**From:** Paul Krohn  
**To:** Burgess, Sonia; Loudon, Patrick > R111  
**Date:** Mon, Jun 28, 2004 6:55 PM  
**Subject:** Point Beach AFW Recirc Valve Pneumatic Capacity

The Site Director of Operations (McCarthy) brought to my attention an issue that a PB engineer had discovered during preparation of a revision to a calculation for the nitrogen backup system for the MDAFWPs. It was discovered that the AFW recirculation AOVs are not set up in conformance with the calculation of record. This issue applies to both the TDAFWP and the MDAFWP.

Unit 2 TBAFWP Air Accumulator

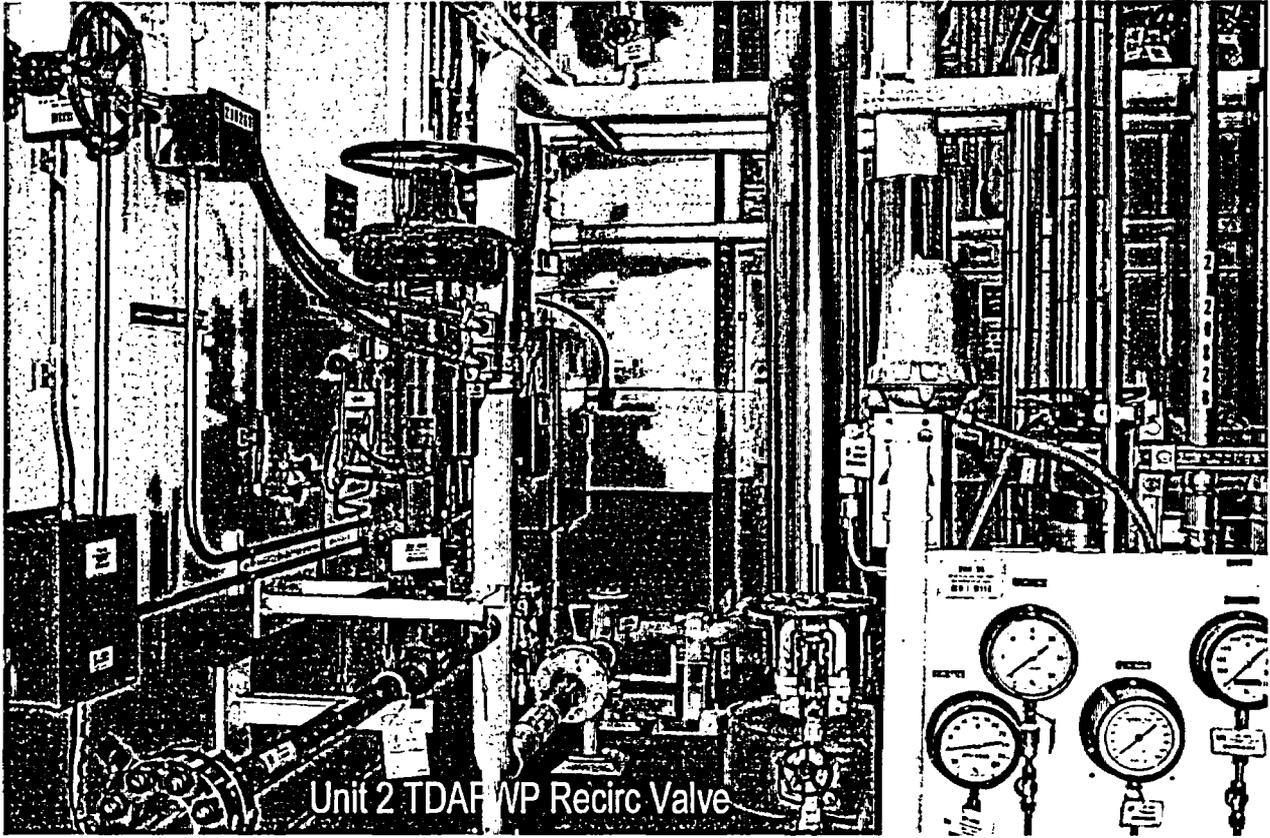
Both calculations require that the AOVs be set such that there is a 1/4" gap between the actuator frame and the diaphragm housing. This sets the dead volume of the actuator, a value that is an input to the calculation which determined the required capacity of the accumulators to provide 10 strokes/hour of the recirculation valves for 2 hours.

Actual walkdown of the installed configuration in the field has revealed gaps ranging between 7/8" to 1 and 7/8."

Using the worst case stroke volumes (600 cubic inches of air) the following results are obtained;

1) the TDAFWP would require a 211 gallon accumulator to provide 10 strokes/hour for 2 hours. The actual accumulator has a volume of 150 gallons.

'B' MDAFWP Recirc Valve

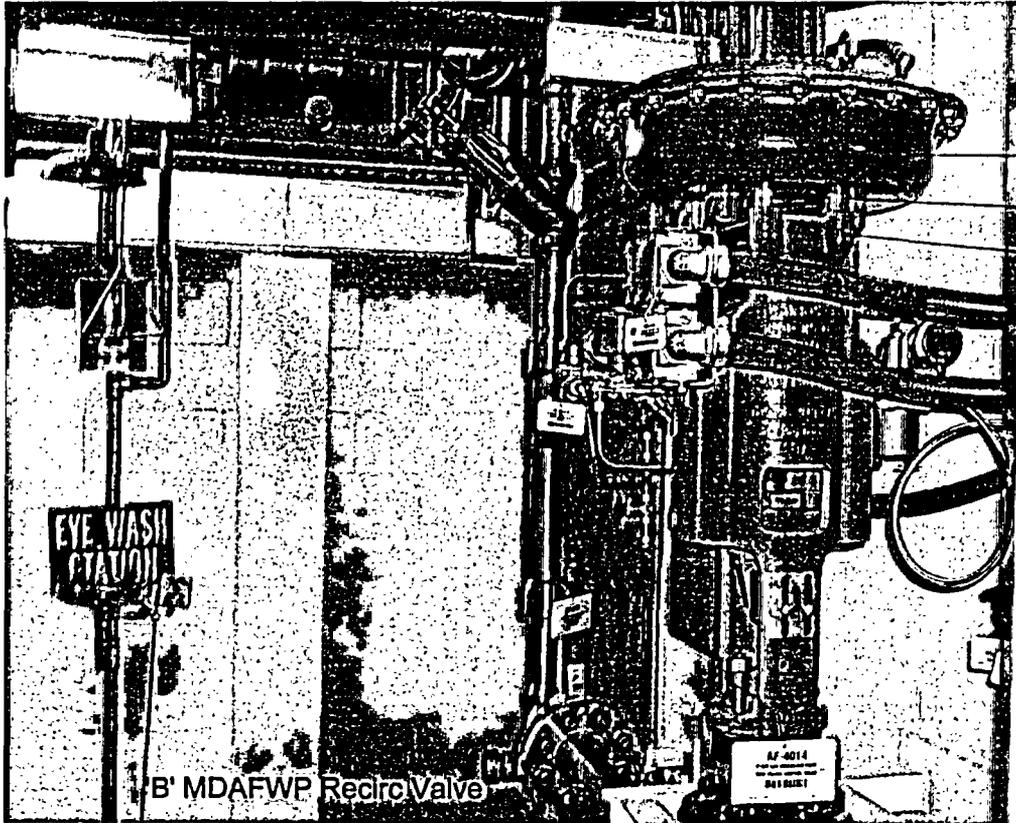
Moves  
Gap  
Fixed
